**STAFF REPORT**  
**COMMUNITY DEVELOPMENT DEPARTMENT**

HEARING DATE: 6/17/2021  
 TO: Planning & Zoning Commission  
 FROM: Joe Dodson, Associate Planner  
 208-884-5533  
 SUBJECT: H-2021-0029  
 ACHD Ustick Maintenance Facility

Annexation and Zoning of 30.27 acres of land with a request for the I-L zoning district for the purpose of constructing an ACHD maintenance facility on 23.7 acres, by Engineering Solutions, LLP.

B. Revised Concept Plan (dated: 4/14/2021)

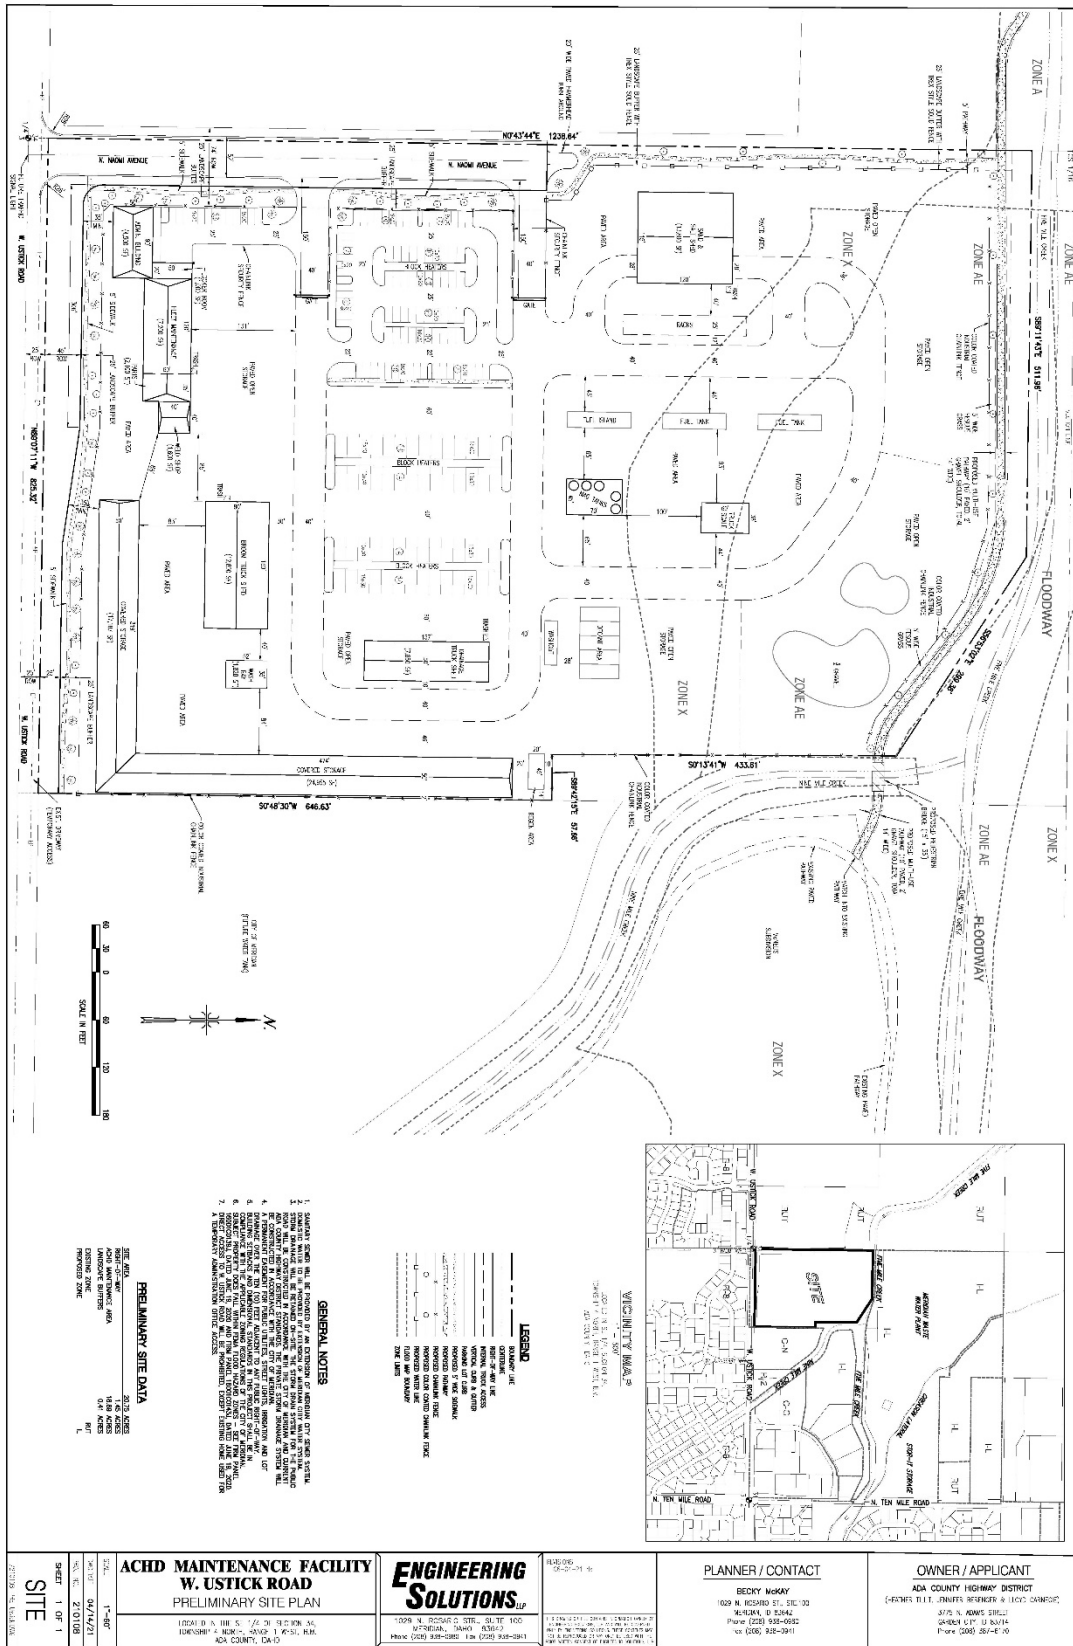
*The concept plan and phasing plan submitted with the application depict specific parts of the maintenance facility being constructed at different times. A revised concept plan has since been submitted. In general, the revised concept plan depicts the following: the required multi-use pathway segment north of the proposed fencing and along the north boundary; a gravel pit and paved open storage along the north and northwest boundary; fuel tanks, truck scale and a salt/sand shed within the central area of the site; central but along the east boundary more paved open storage and the decant and washout stations are proposed; employee and fleet parking as well as the drain truck shed are located in a majority of the center of the site; in the south and southeast area of the site the administration building, fleet maintenance building, broom truck shed, and covered storage is shown on the concept plan.*

*Please see the phasing plan in the exhibit section below (Exhibit VII.E) for when these areas are proposed to be constructed from approximately 2021-2028. Staff notes that the location of the decant and washout areas have been moved since the revised concept plan was submitted to a new location outside of the floodplain and is therefore not accurately shown on the phasing plan.*

*The submitted concept plan shows compliance with all of the requirements surrounding the construction of the multi-use pathway except for the required landscaping along both sides of the pathway. The north side of the pathway is encumbered by the irrigation easement so the Applicant has proposed trees only along the south side of the pathway. Staff is not necessarily against this but the Applicant should be required to apply for Alternative Compliance with the first CZC to determine the adequate alternative to the landscaping requirement along the creek. To ensure these pedestrian facilities are constructed, especially the multi-use pathway segment, Staff is recommending the pathway and sidewalks are constructed with phase 1 when the landscaping and fencing are proposed.*

*The revised color concept plan shows lawn and trees within each required landscape area. As noted previously, Staff is recommending denser landscaping within the landscape buffer to Ustick Road to help mitigate any noise, light, or fumes from the maintenance facility. Furthermore, the landscape buffers should be constructed with phase 1 for this exact reason. The landscaping shown on the color concept plan appears to meet code requirements but further analysis will be done with the first CZC submittal and a specific landscape plan is submitted.*

C. Color Concept Plan

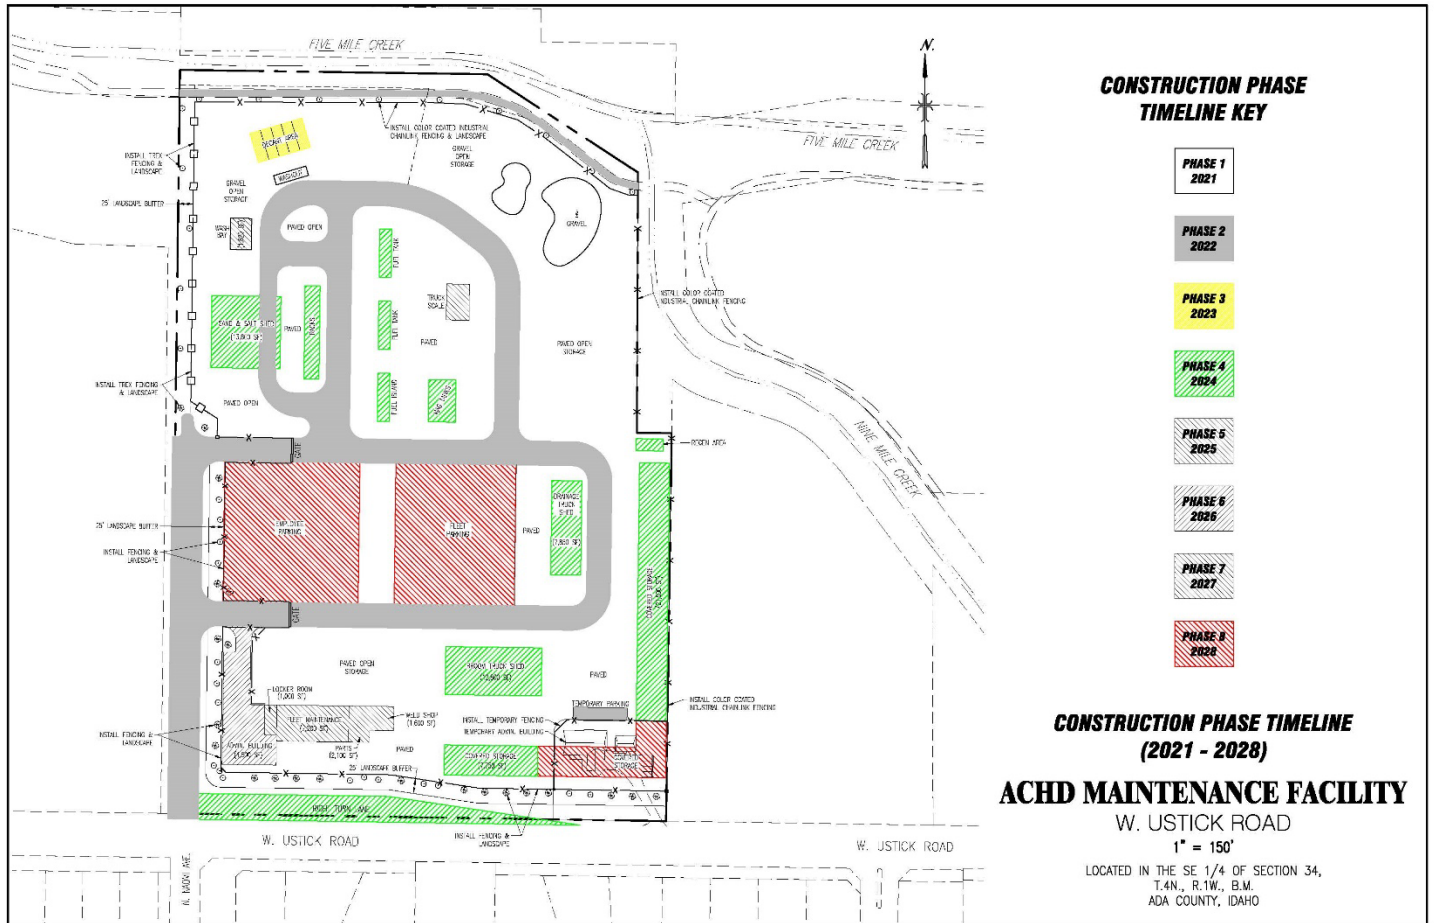
The Applicant is required to construct landscape buffers along Ustick Road, Naomi Avenue, and the remaining western boundary. In addition, the Applicant is required to install landscaping along the multi-use pathway along the north property. The buffers along Ustick and Naomi are governed by UDC 11-3B-7; the land use buffer along the remaining west property boundary is governed by UDC 11-3B-9; and the multi-use pathway landscaping is governed by UDC 11-3B-12. The Applicant did not submit specific landscape plans for the project but the revised color concept plan (Exhibit VII.C) does depict proposed landscaping in the required areas.
